Final PM_{2.5} Project-Level Conformity Analysis for the Louisville-Southern Indiana Ohio River Bridges Project in Louisville, Kentucky

Document created by:
Division of Planning
Kentucky Transportation Cabinet
Division of Planning
January 8, 2007

Revised: March 27, 2012

Appendix D: Public Comments and KYTC Responses on the January 2007 Analysis

Figure 4 - LSIORB Project Schedule Overview

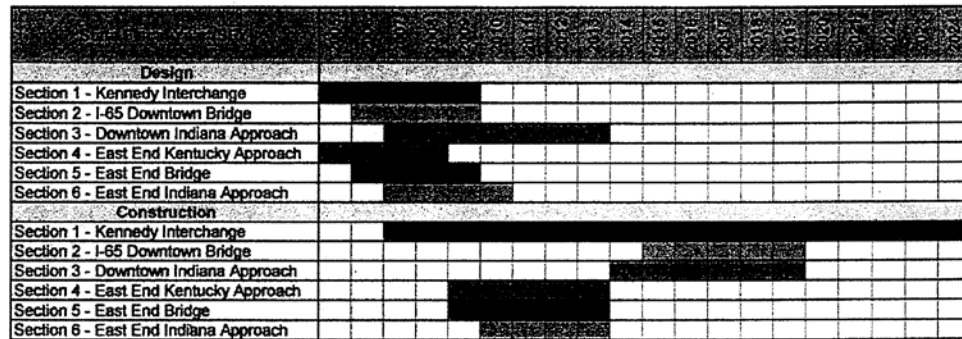
There are several problems with the hot-spot analysis regarding construction emissions. First, the construction schedule in Exhibit 6, p. 14, is incorrect and cannot serve as a basis for a valid conformity determination. On Dec. 1, the Transportation Cabinet submitted a required Long-Range Plan for the project that includes a construction schedule (included in these comments as Attachment 1). That schedule is lengthened from the hot-spot analysis schedule, substantially so for the Kennedy Interchange construction. The Cabinet’s own document identifies an 18-yr. construction period for the Kennedy Interchange and a 6-yr. period for construction of the Indiana I-65 approach. In no stretch of the imagination can such activities be considered “temporary.”

- Did not require consideration of temporary emission increases from construction-related activities as the bridges project would be constructed in segments and divided into different individual construction sites. As such, localized construction emissions can be considered separately and temporary as construction-related emissions at each individual construction site is anticipated to be less than five years.
- Was included in the Louisville Area’s Metropolitan Planning Organizations fiscally constrained Long Range Transportation Plan and Transportation Improvement Program which were found to conform on March 3, 2006.
- Did not result in any significant environmental impacts that were not already evaluated in the EIS, and that no violations of the PM_{2.5} standard are likely to occur.
